September 4, 2015

**ADDENDUM #7**  
**IFB #16-22**  
**Leo A. Roy & Lower Locks**  
**Parking Garage Restoration Project**

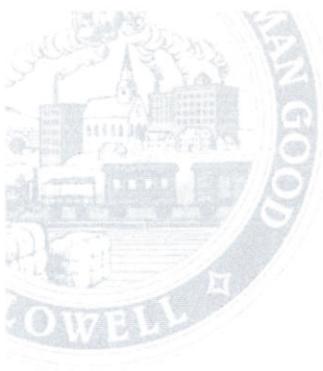
Detail 40.3/R603 directs to “remove and replace steel plate or bar stock flange connection”. Please provide a length considering this is a “per each” unit price item.  
Answer - The length of the plate or bar stock 4 inches.
